BRUNSWICK STEAM ELECTRIC PLANT, UNIT 1 AND 2
NRC DOCKETS 50-325 AND 50-324
OPERATING LICENSES DPR-71 AND DPR-62
REQUEST FOR LICENSE AMENDMENTS
PRESSURE-TEMPERATURE LIMITS CURVES

TYPED TECHNICAL SPECIFICATION AND BASES PAGES - UNIT 2

MARKED-UP TECHNICAL SPECIFICATION AND BASES PAGES - UNIT 1

MARKED-UP TECHNICAL SPECIFICATION AND BASES PAGES - UNIT 2

FIGURE 3.4.6.1-1
PRESSURE-TEMPERATURE LIMITS
REACTOR VESSEL

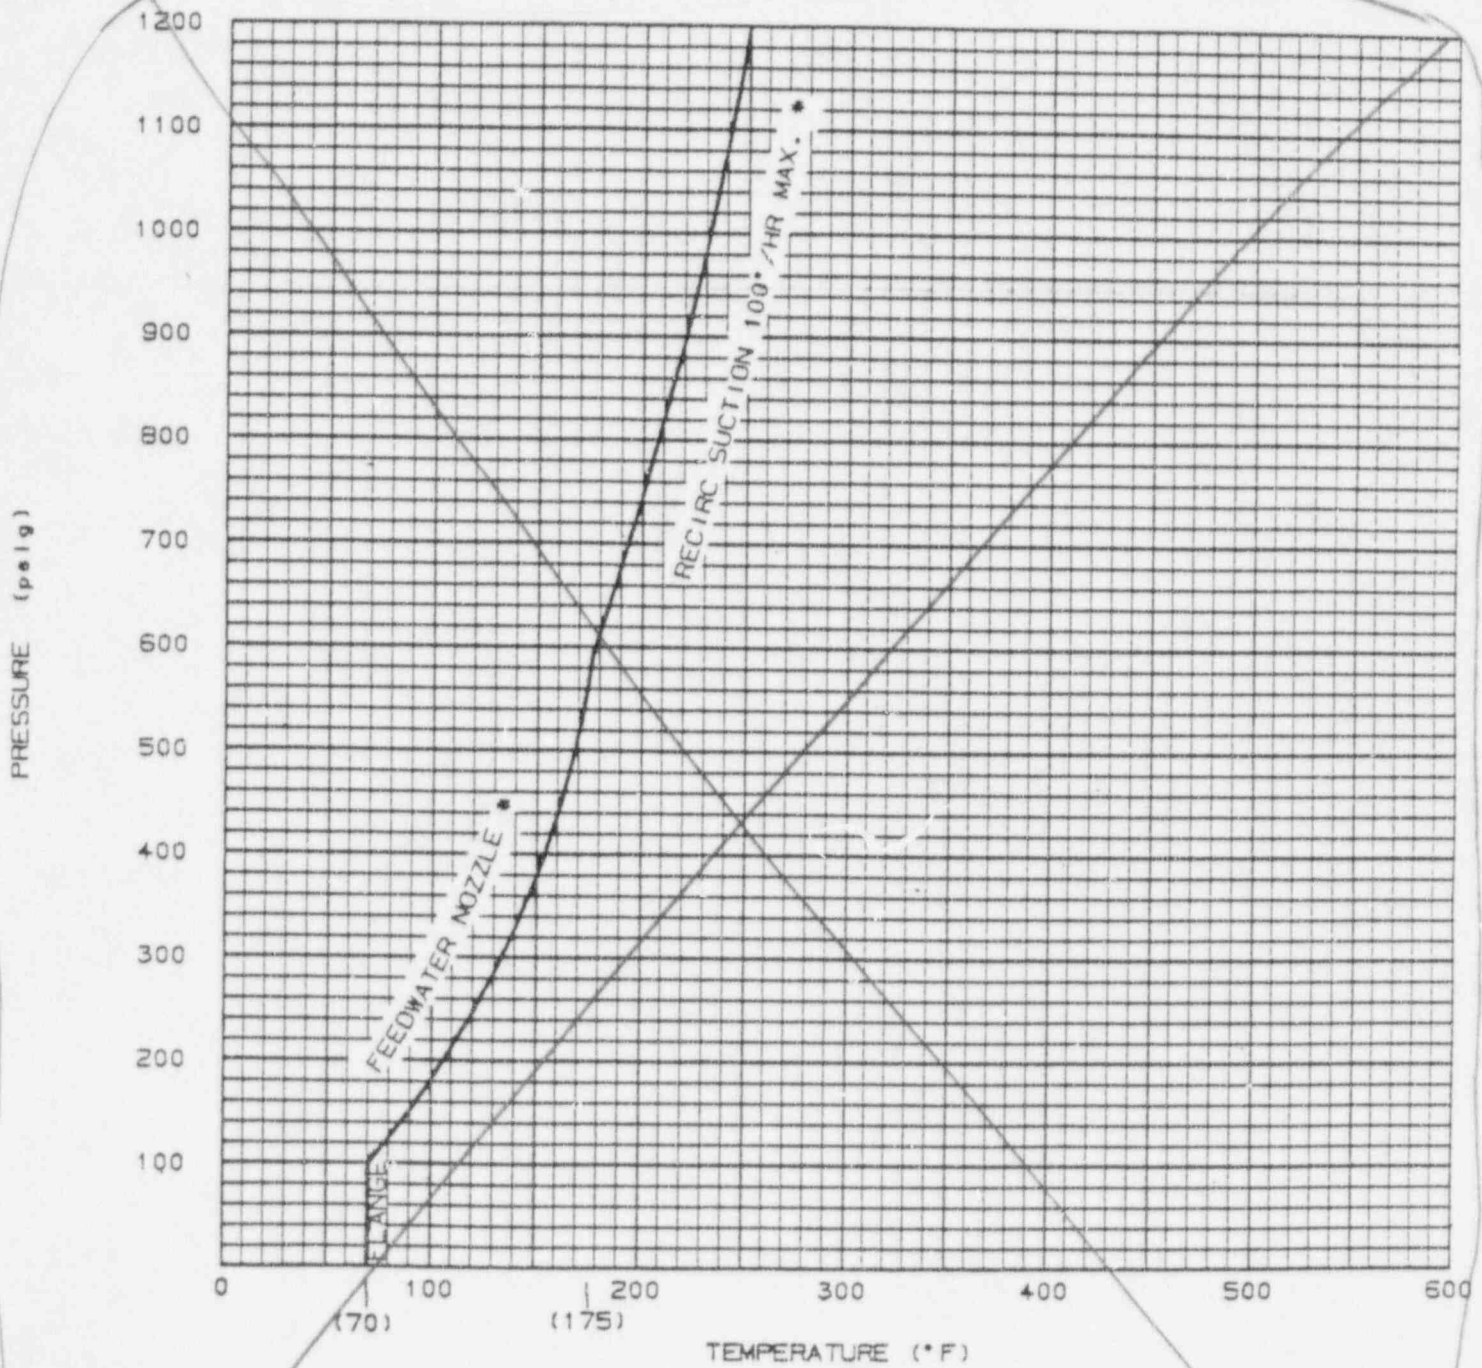
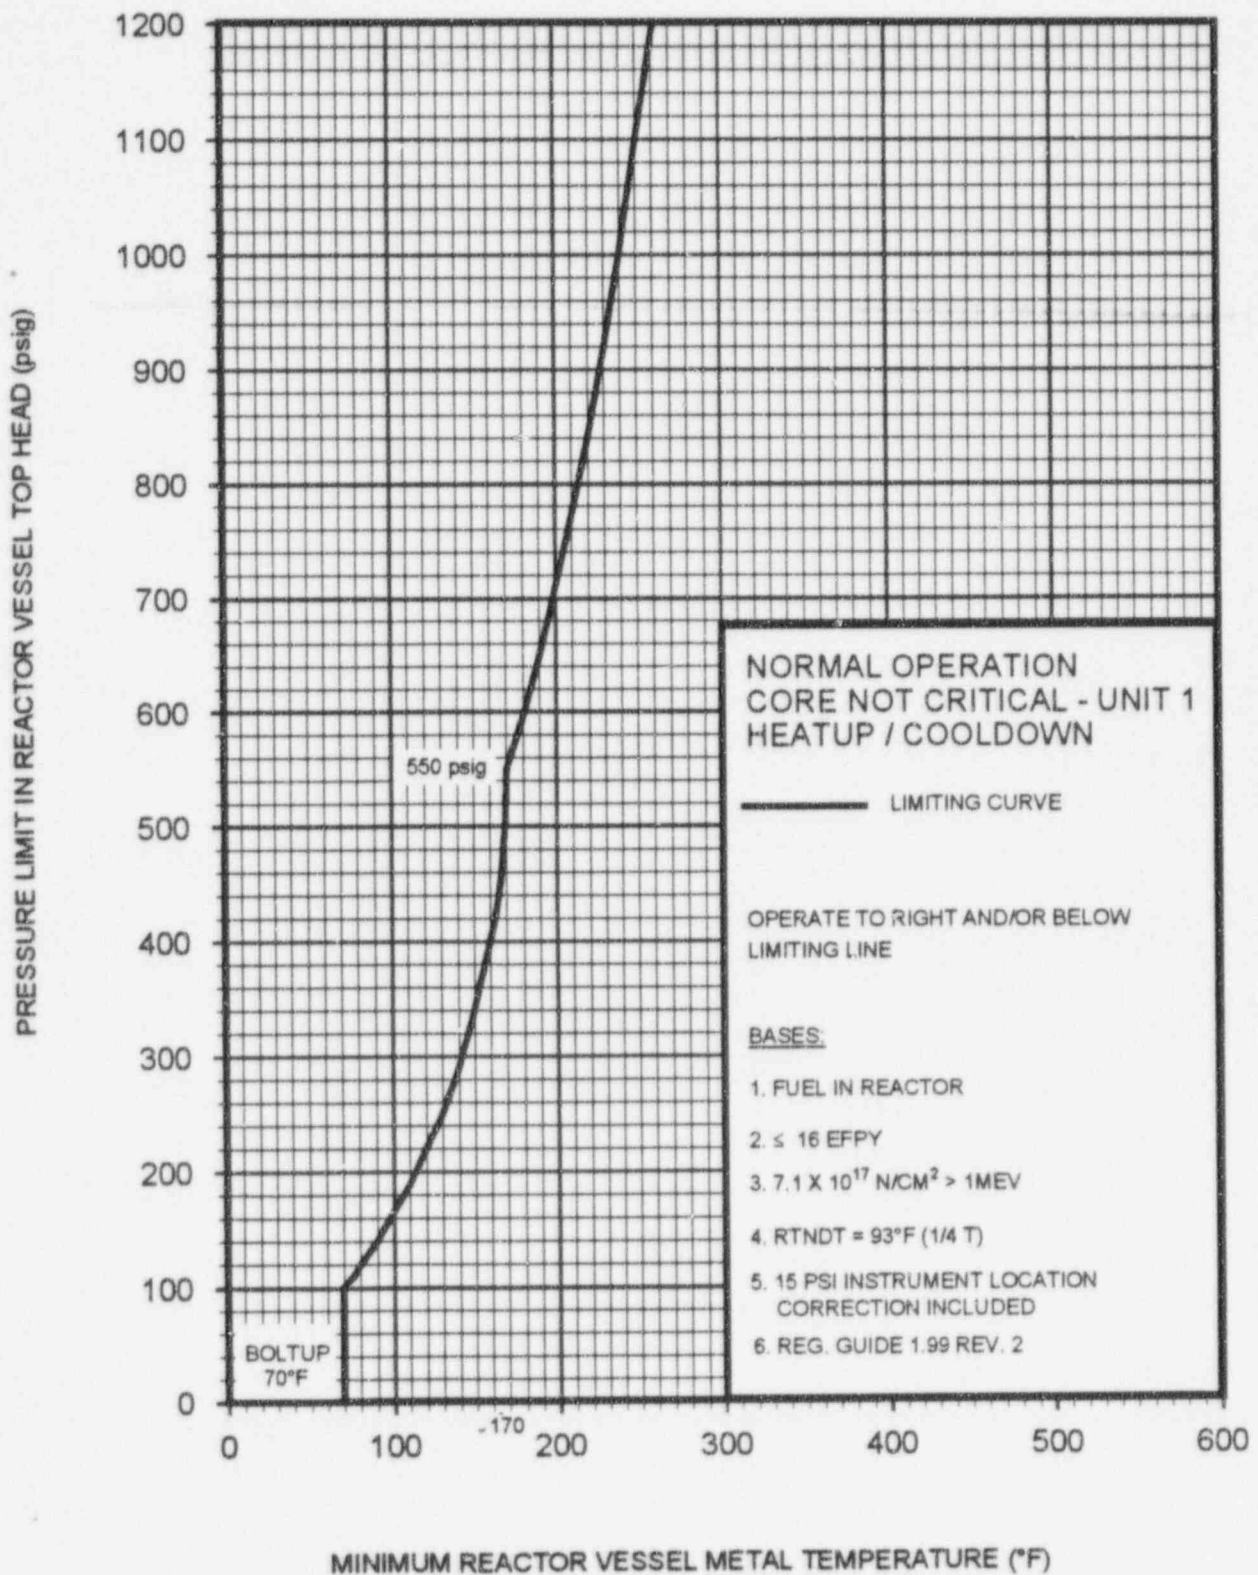
Insert 3.4.6.1-1

Insert 3.4.6.1 - 1

FIGURE 3.4.6.1-2
PRESSURE-TEMPERATURE LIMITS
REACTOR VESSEL

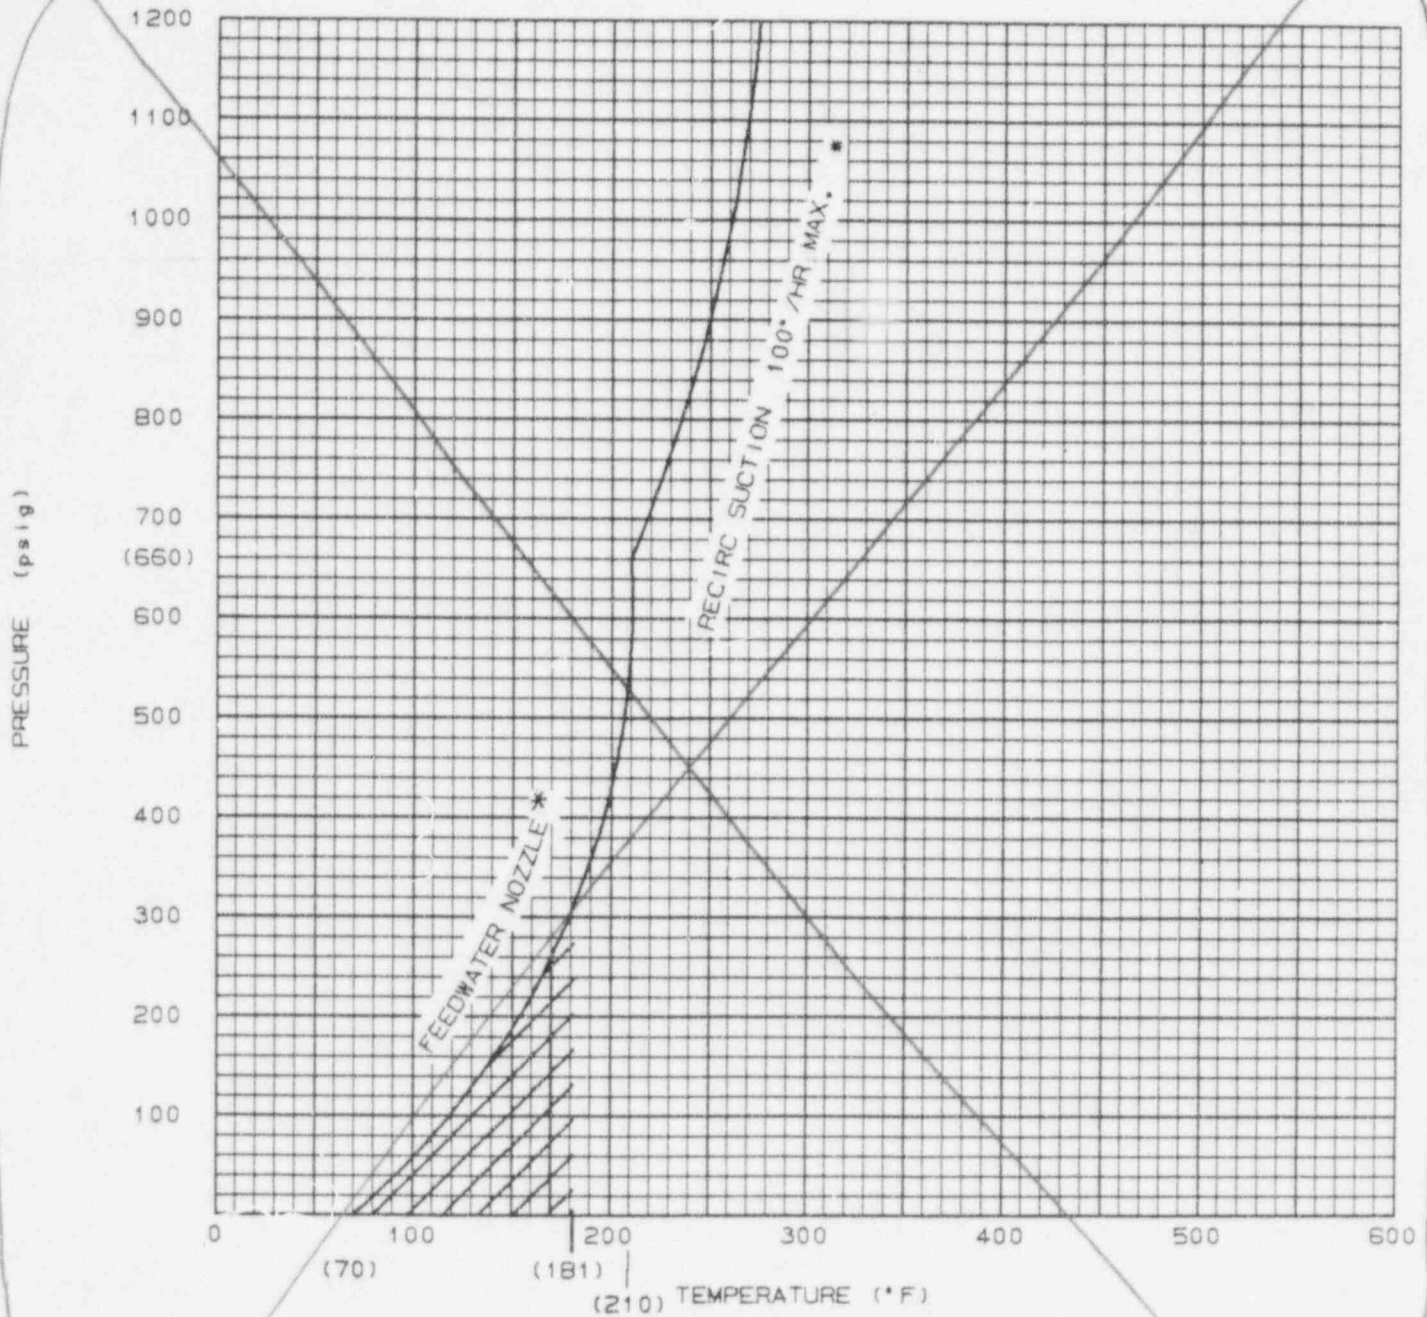
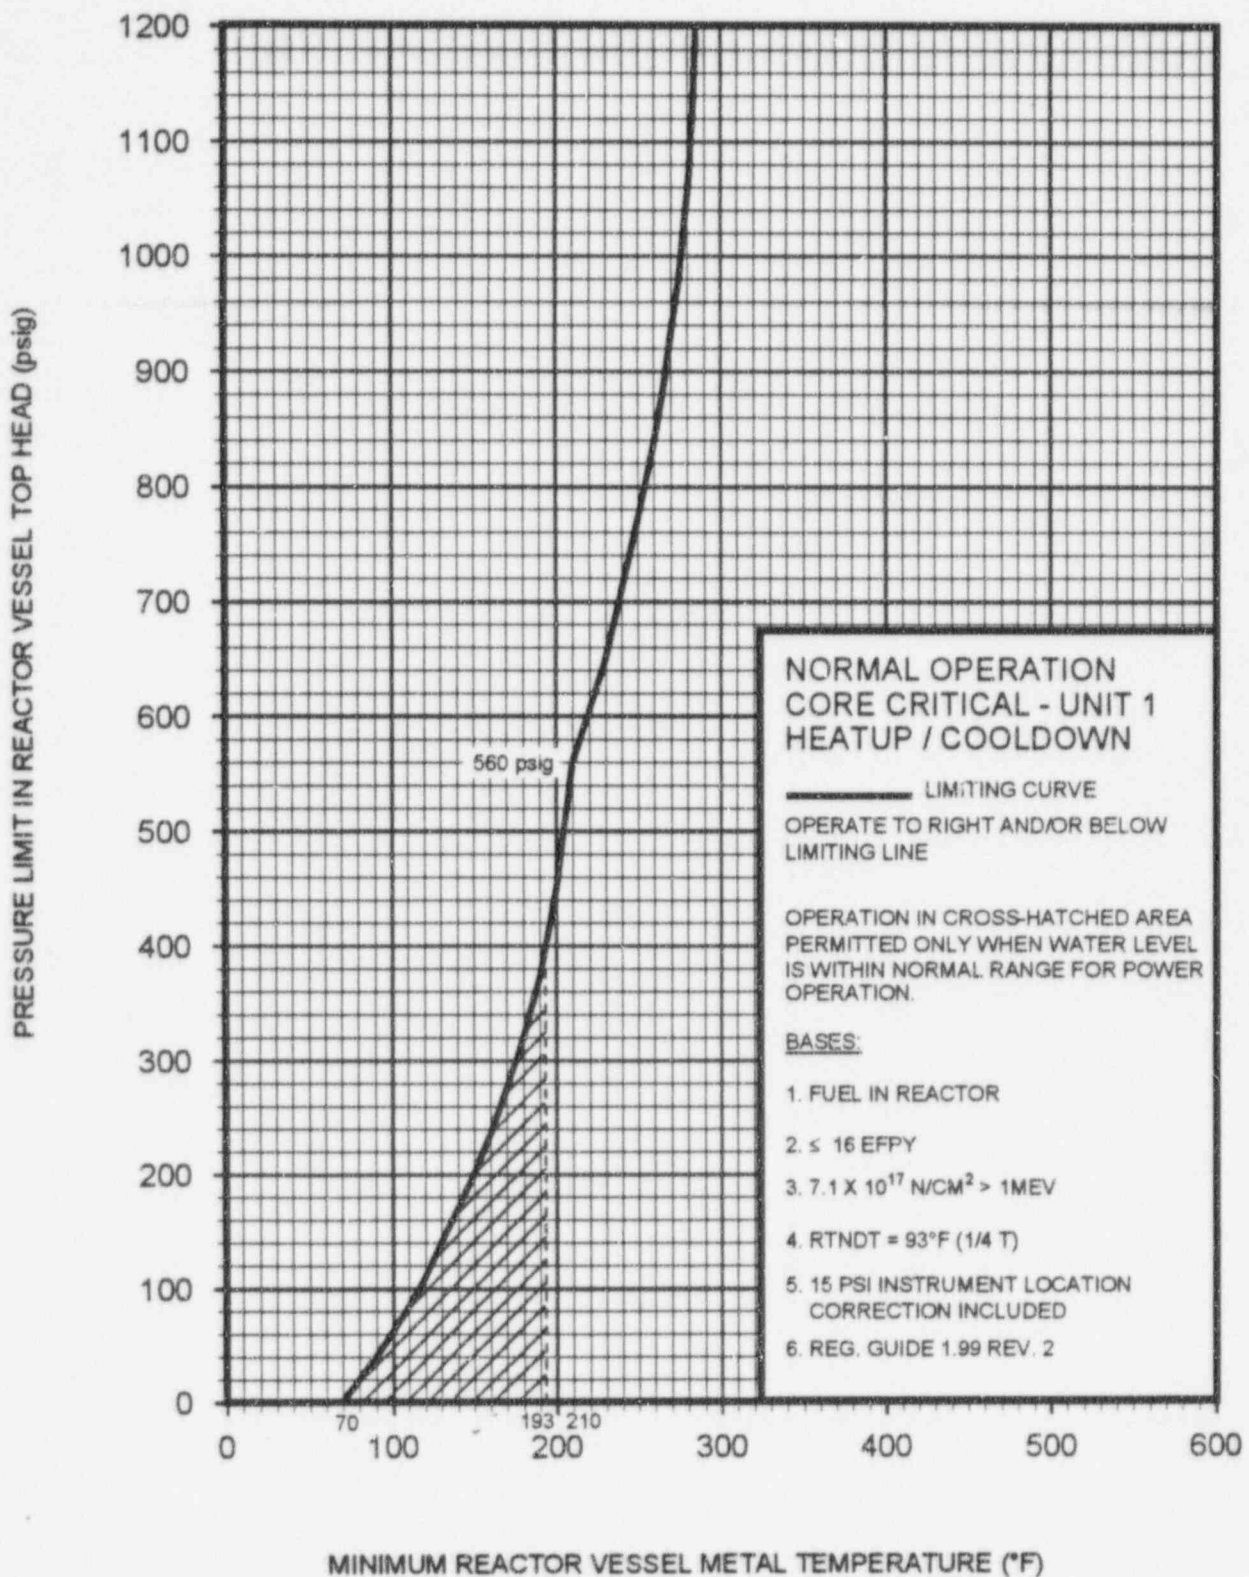
Insert 3.4.6.1-2

Insert 3.4.6.1 - 2
